FACILITY COMPLIANCE INSPECTION REPORT
Division of Waste Management
Solid Waste Section

AAA Hauling of NC, Inc., 1171 S. Eastern Blvd, Fayetteville, North Carolina

PURPOSE OF SITE VISIT: NOCV extension and compliance follow up inspection.

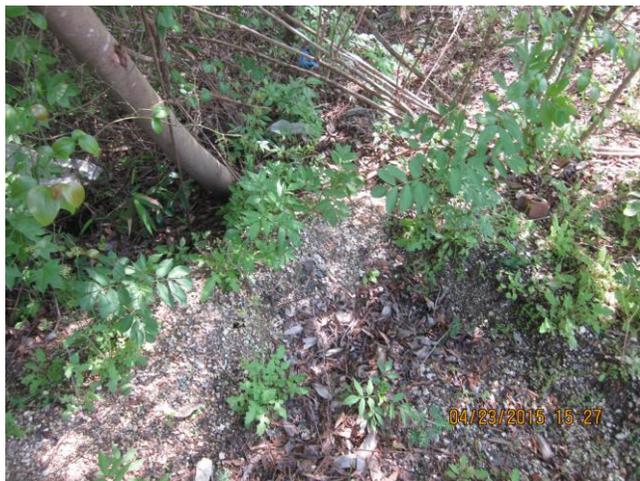
C&D fines waste not removed from area.

C&D fines fill along area not removed.

C&D fines east berm of transfer site.

Comingled crushed waste pile.

Close of berm waste adjacent to office.

Overgrown berm waste adjacent to building.
